17/18-MB1: Organic Farm Parking Lot Improvement, Indian Valley Campus

ADDENDUM #2

Bid Addendum No. 2

Date of Issuance: 02 August 2017
Project Name: College of Marin Indian Valley Campus
Organic Farm Parking Lot Improvements
Project Number: 1102-0005
Client: College of Marin

ORGANIC FARM LOWER PARKING LOT PLANTING PLAN K1

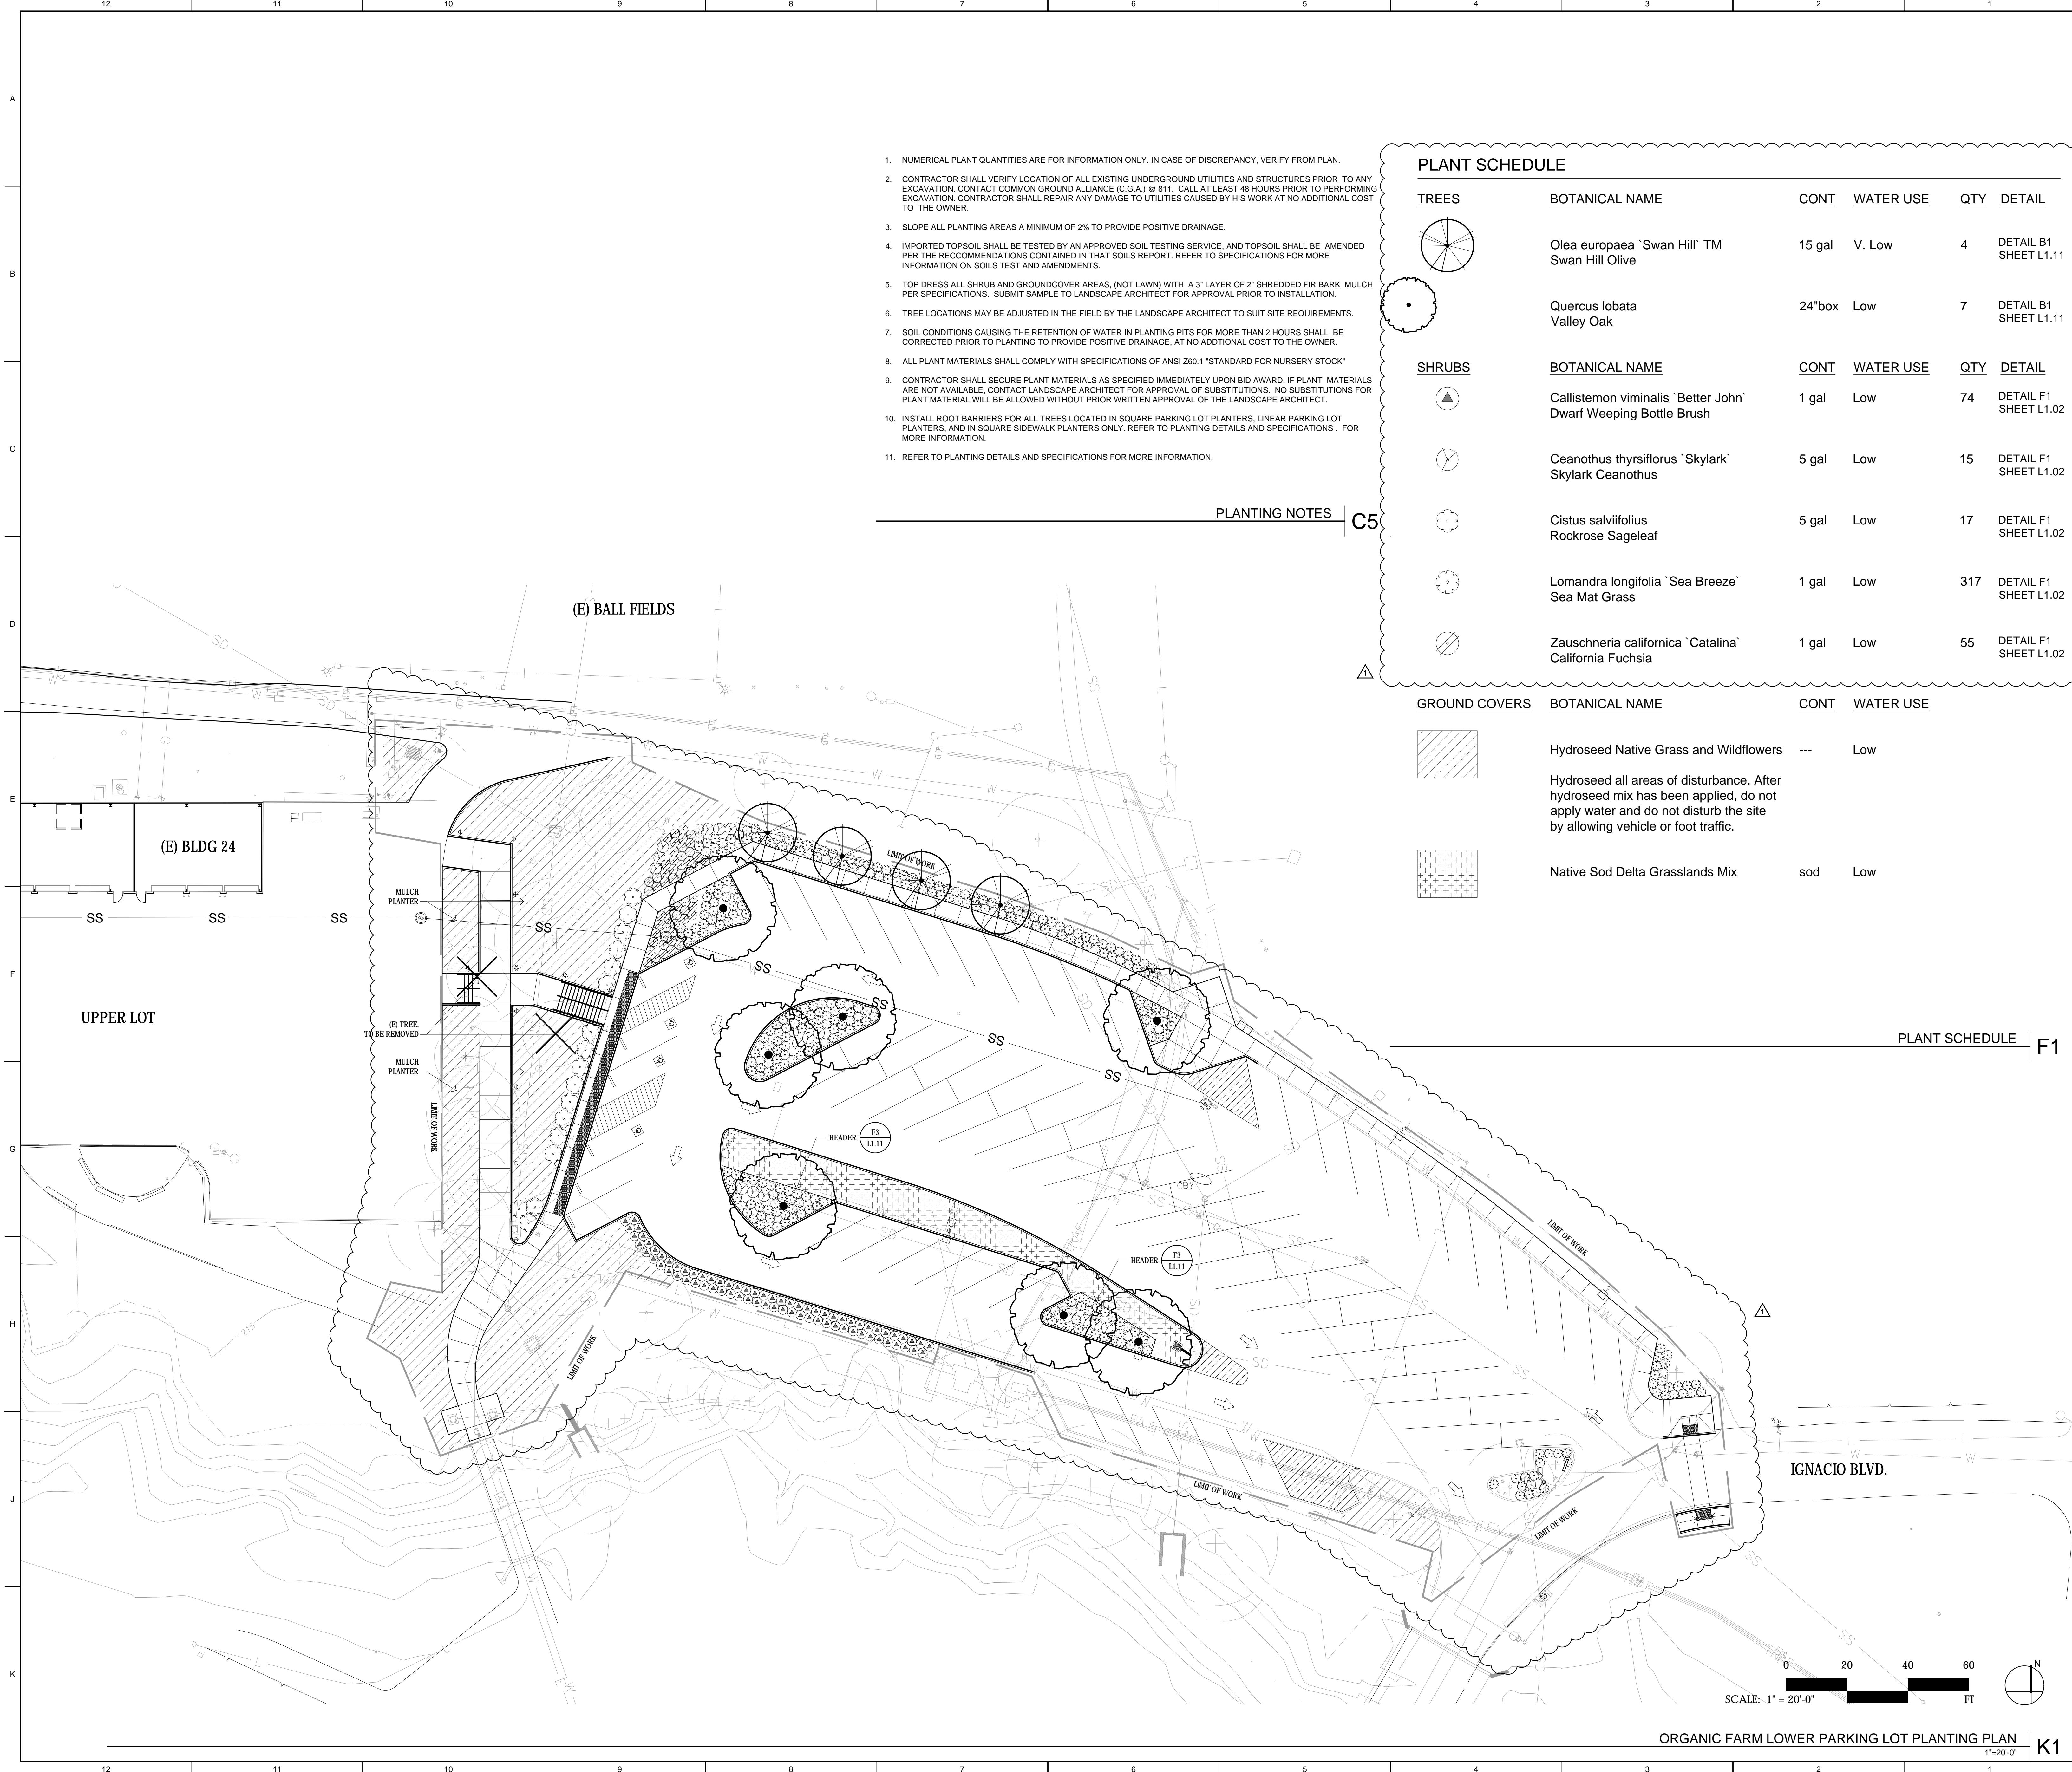
- L1.00 Landscape Plan (Replacement sheet)
 - Parking lot and stair layout revisions
- L2.00 Irrigation Plan (Replacement Sheet)
 - Parking lot and stair layout revisions
